10/649,989 PATENT

RESPONSE UNDER 37 CFR §1.116, EXPEDITED PROCEDURE REQUESTED

Atty. Docket No. 100-22600 (P05659)

Annotated Marked-Up Drawing

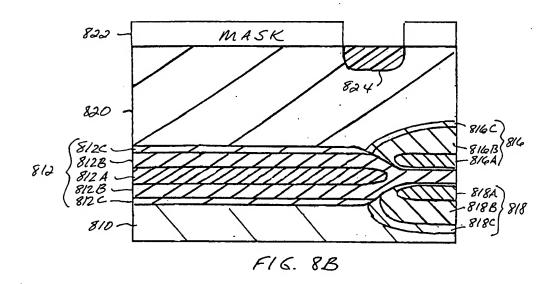
Applicant requests permission to amend FIGS. 5 and 6 as shown in red on a marked-up copy of FIGS. 5 and 6 to add reference numeral 112. In addition, applicant requests permission to amend FIG. 8C as shown in red on a marked-up copy of FIG. 8C to change the top reference numeral 812A to 812C. The marked-up copies of FIGS. 5, 6, and 8C are attached in Appendix A.
